SOLICITATION AMENDMENT

Title - Sujet Tow Tank Wave Generator	
Solicitation No. - N° de l'invitation 31184-161177/A	Amendment No. - N° modif. 002
Client Reference No. - N° de référence du client 31184-161177	Date 2016-09-12
GETS Reference No. - N° de référence de SEAG PW-\$XAQ-031-6650	
File No. - N° de dossier XAQ-6-39047 (031)	CCC No./N° CCC - FMS No./N° VME
Solicitation Closes - L'invitation prend fin at - à 02:00 PM on - le 2016-09-15	
Time Zone Fuseau horaire Newfoundland Daylight Saving Time NDT	
F.O.B. - F.A.B. Plant-Usine: <input type="checkbox"/> Destination: <input checked="" type="checkbox"/> Other-Autre: <input type="checkbox"/>	
Address Enquiries to: - Adresser toutes questions à: Baird, Janice	Buyer Id - Id de l'acheteur xaq031
Telephone No. - N° de téléphone (709) 772-2999 ()	FAX No. - N° de FAX (709) 772-4603
Destination - of Goods, Services, and Construction: Destination - des biens, services et construction: National Research Council Canada Kerwin Place and Arctic Avenue P.O. Box 12093, Station A St. John's, NL A1B 3T5

1. Provide the following technical questions and answers.

CWT II elevation 3

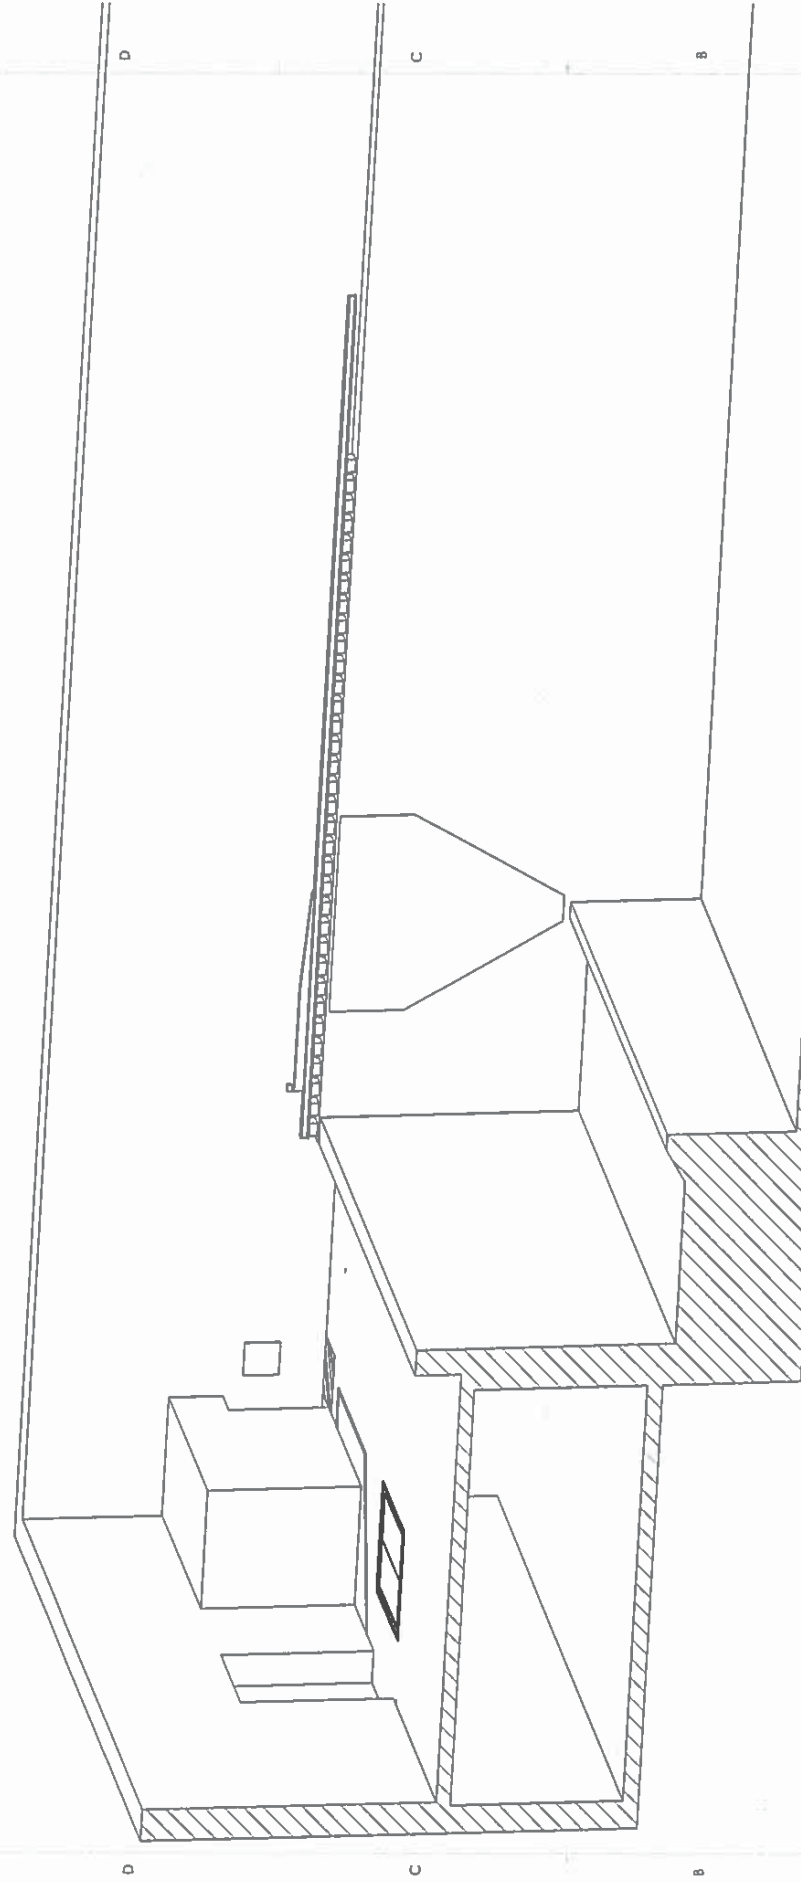
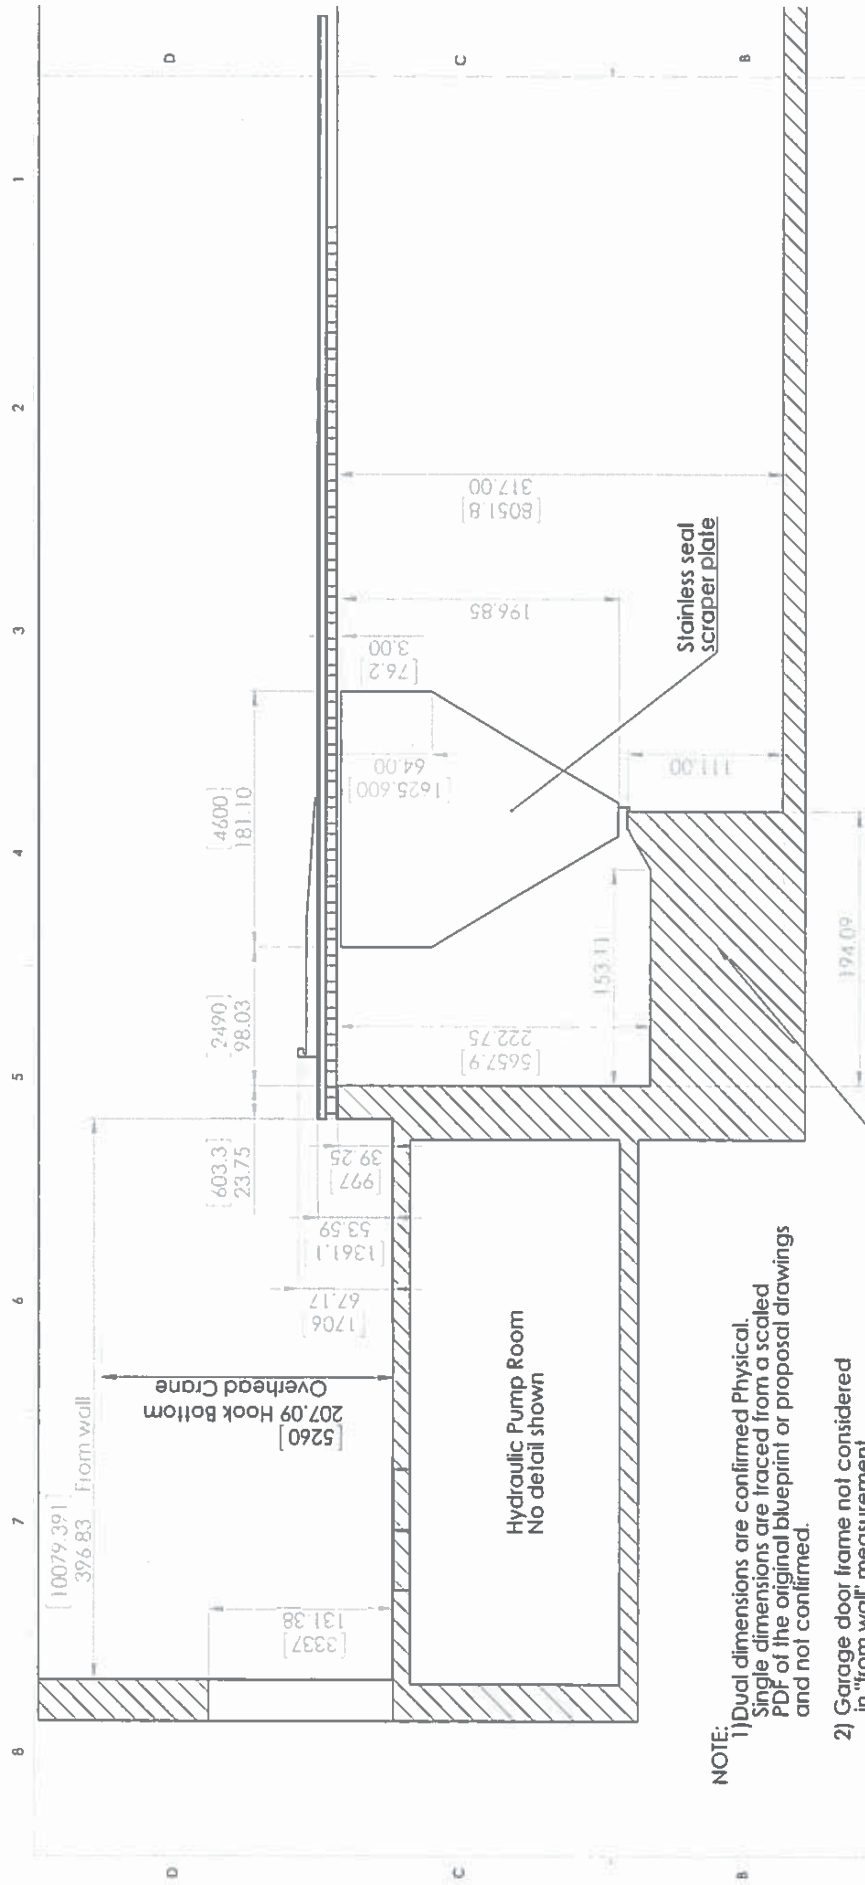
Q1. Please confirm if we are able to utilise the existing wave absorption beach.

A1. Currently as the wave generator is a dry back design, there is no wave absorption beaches on the rear side of the wave generator, see attached drawings.

The new wave generator is a wet back design, the supplier must include wave absorption beaches on the rear side of the wave generator as part of their deliverables.
